Tote Road Quarry Expansion Project

Environmental Assessment Additional Information Addendum

Scotian Materials Limited

09 November 2022

CROSS-SECTION B-B'

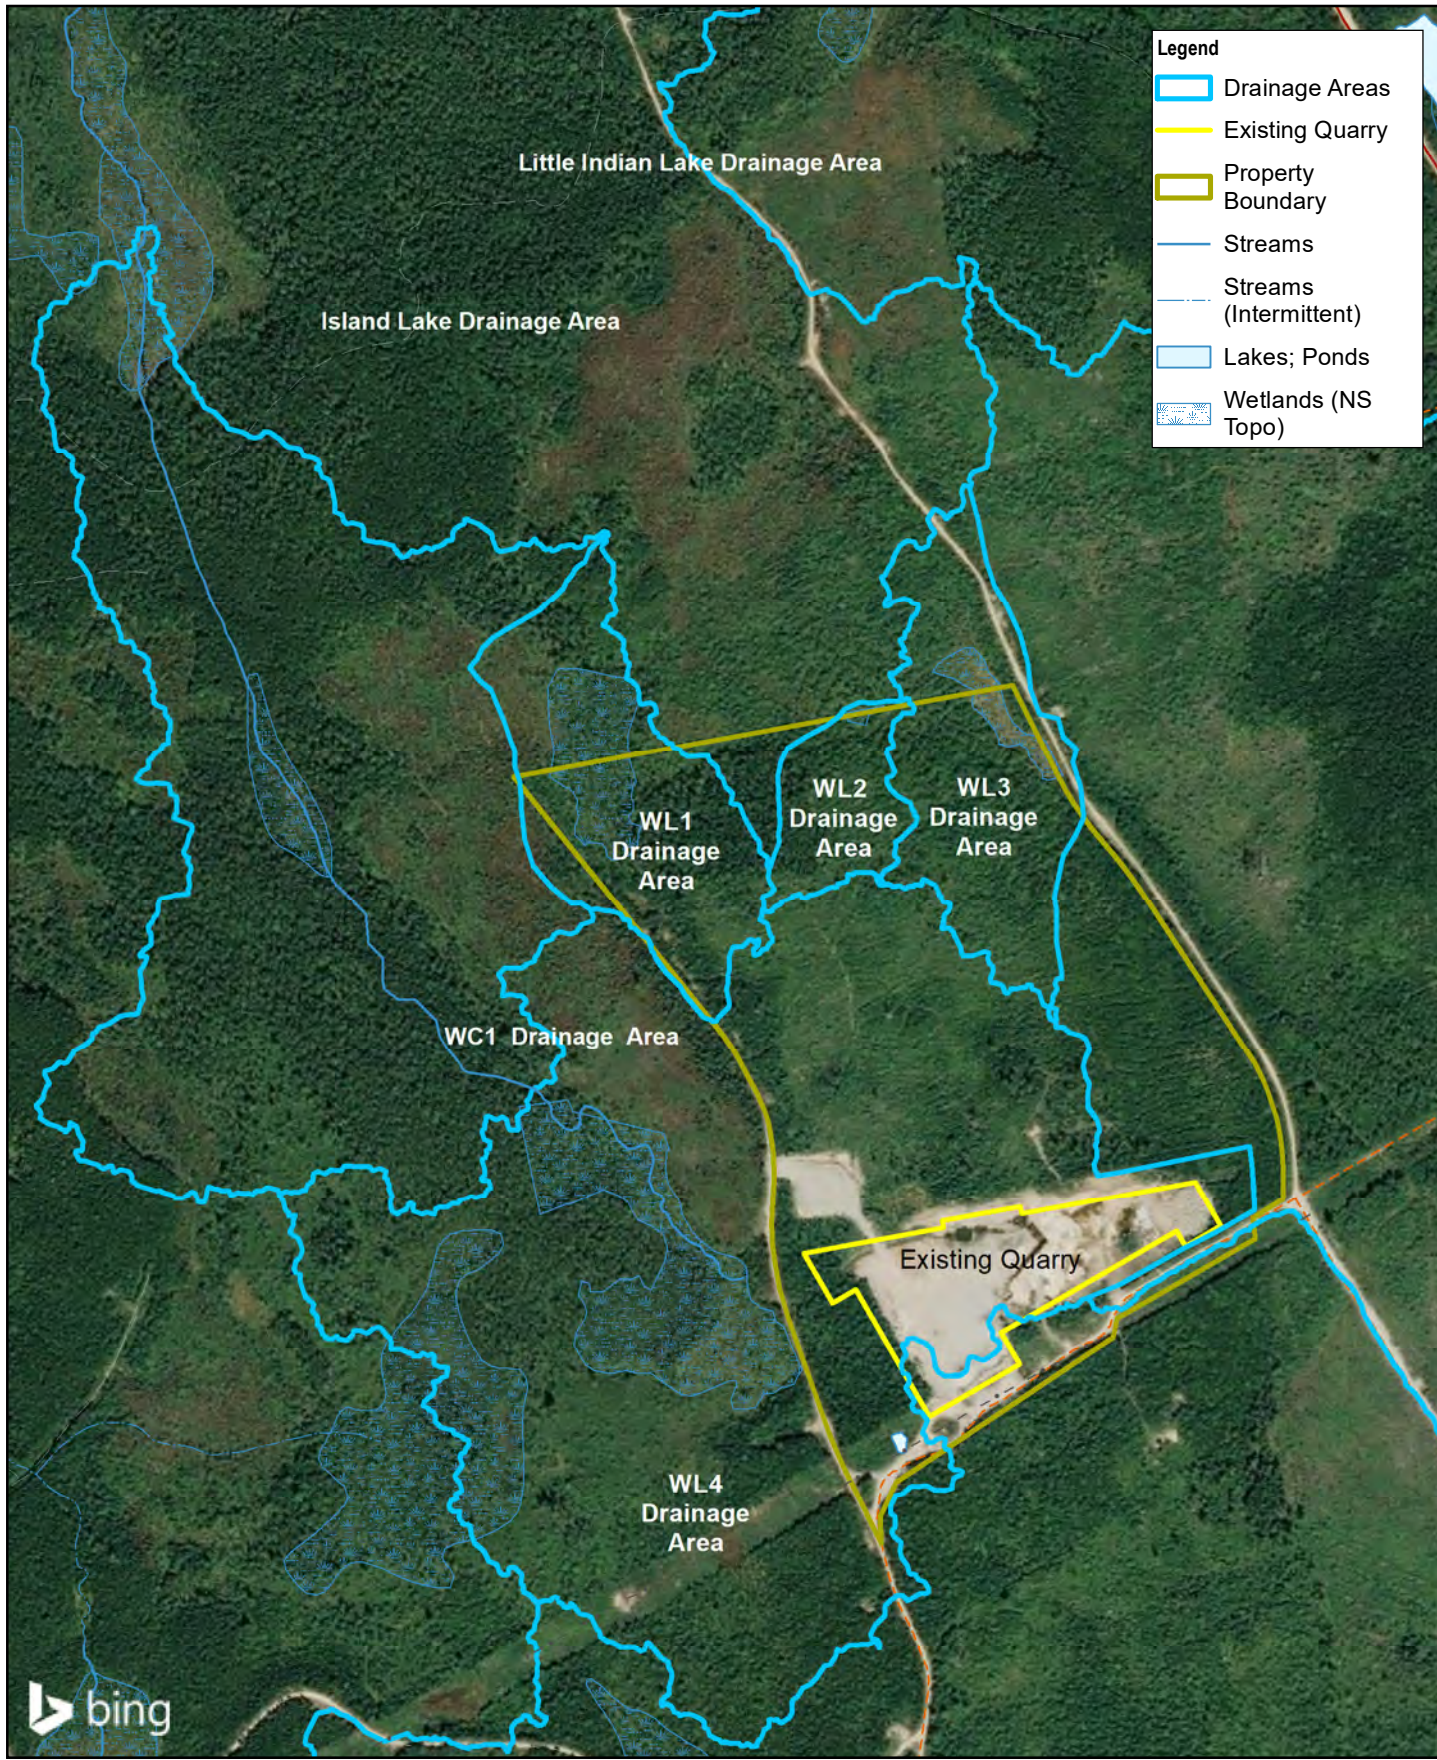
Provide mapping views and cross-sectional details for the proposed final quarry depths/elevations/width, current location of the water table and relevant off-site wetland elevations.

Figures 3 through 5 provide a cross section location map and geologic cross sections through the existing and expanded quarry. The cross sections show the monitoring wells, groundwater elevations and expanded quarry floor. These cross sections indicate the proposed quarry floor will be beneath the water table.

The mapping and cross-sectional details of the proposed final quarry depths, elevations and width along with the water table and the locations of the wetland features are shown in Figures 3, 4 and 5 (attached).

BASELINE WATERSHED DELINEATION

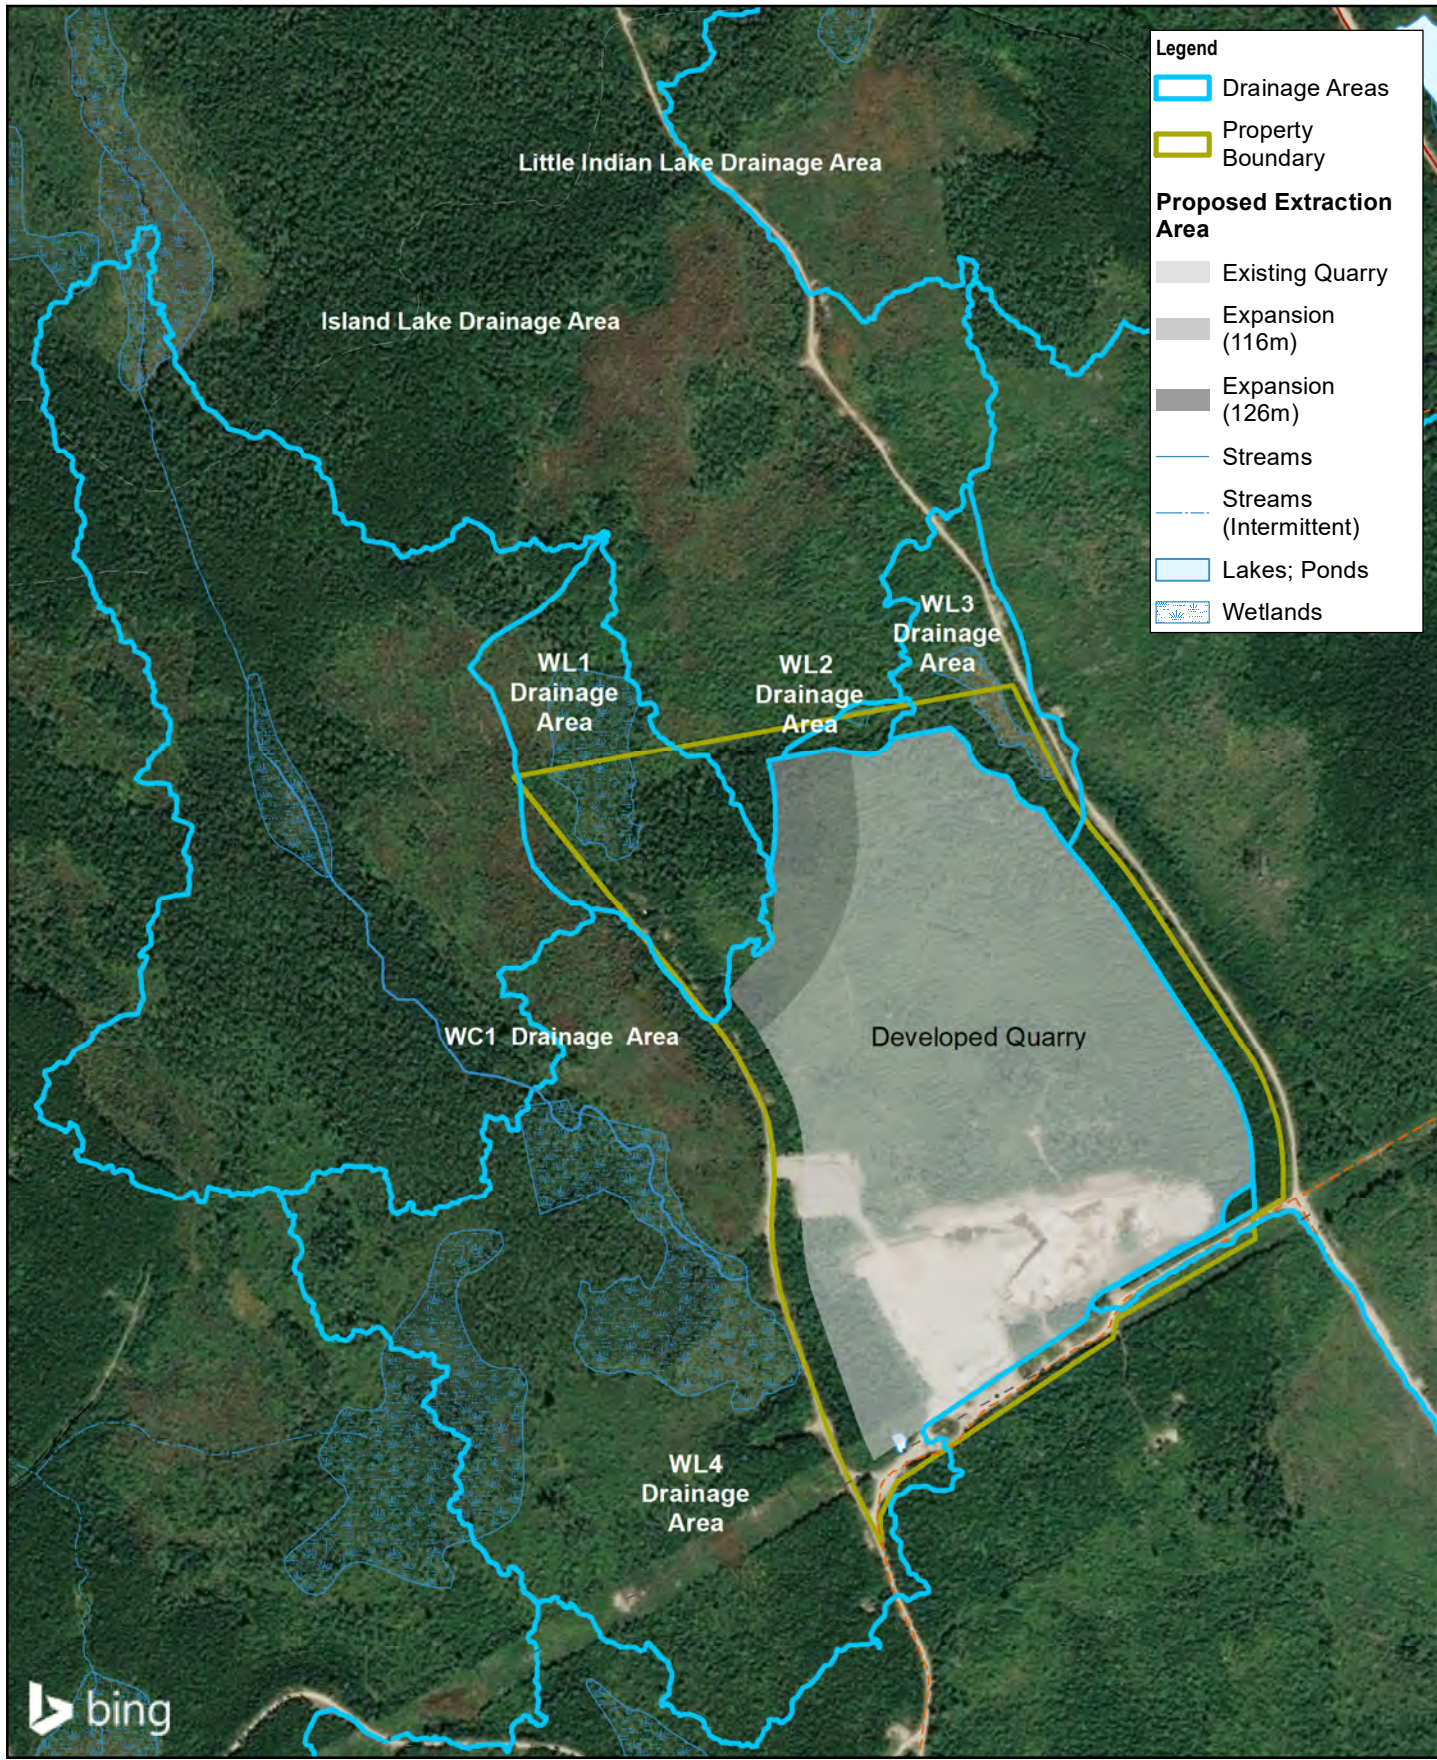
Assessment of impacts to wetlands due to drainage area and surface water runoff. Methodology for the catchment area delineation shall be provided.

The proposed expanded quarry was revised to avoid intercepting the catchment area of WL1, which was previously identified as a wetland of special significance. Baseline watersheds for the adjacent watercourse and wetlands are shown in Figure 6, and EOQ and reclamation watersheds are shown in Figure 7.

CONSTRUCTION DETAILS

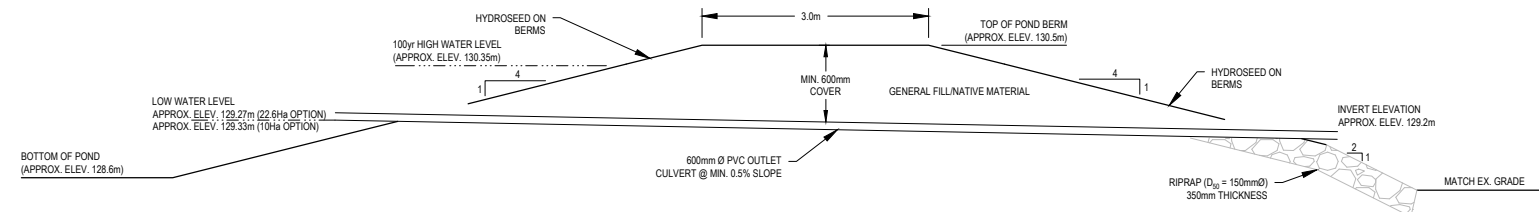
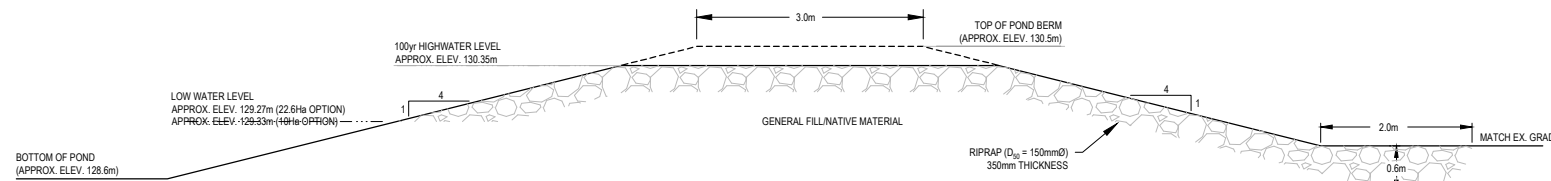
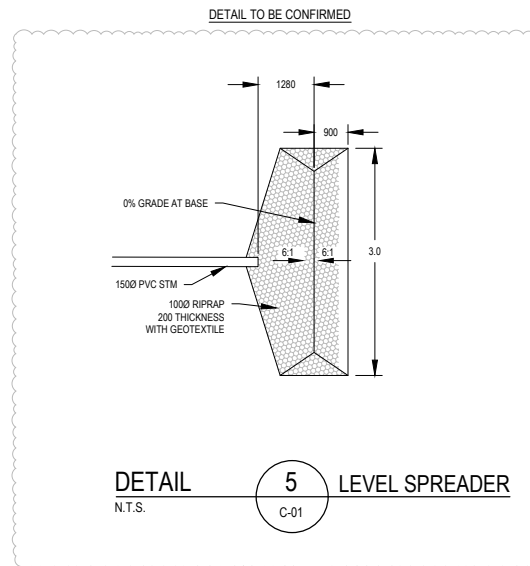
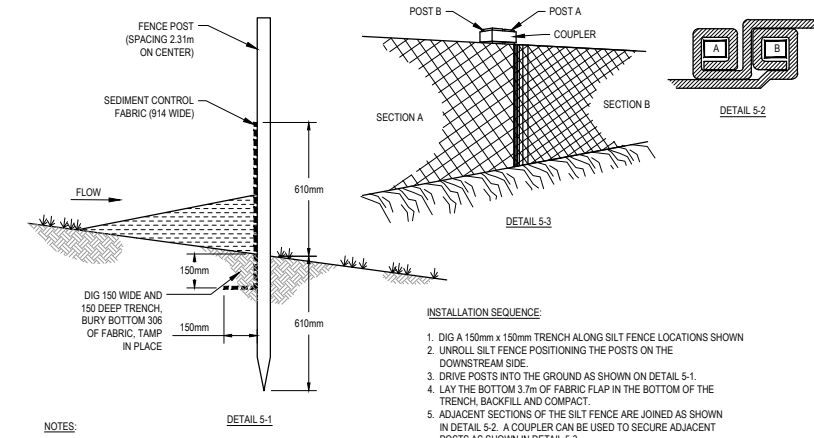
Detailed information on the existing quarry site surface water drainage and management, and on the proposed surface water management through the various phases of the quarry expansion.

The settling pond design and construction details are presented in Drawings C-01A, C-01B, and C-02 in Appendix A. The settling pond is required for the treatment of stormwater runoff from the Project. To ensure adequate sedimentation control for current conditions and future expansion of the quarry, a settling pond will be constructed in advance of the Project development. The design of the settling pond was developed based on the requirements of the Nova Scotia Department of Environment Erosion and Sediment Control Handbook for Construction Sites (1988).
